Proposed Revisions to a Standard Plans Index

Originator:	Turley, Joshua	Index Number:	455-112
Date:	8/21/2024	Sheet Number(s):	2
E-mail:	Joshua.Turley@dot.state.fl.us	Index Title:	12" SQUARE CFRP & SS PRESTRESSED CONCRETE PILE

12" SQUARE CFRP & SS PRESTRESSED
CONCRETE PILE

STRAND PATTERN

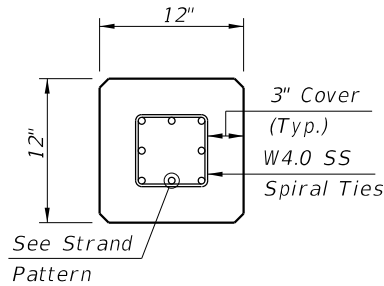
Sheet 2: Adjusted Strand Pattern diameter decimal places

This is a more accurate representation of the nominal diameter driven by the fact that the strands are fabricated in millimeters not inches.

8 ~ 0.52" Ø, HSSS at 24 kips
8 ~ 0.62" Ø, HSSS at 26 kips
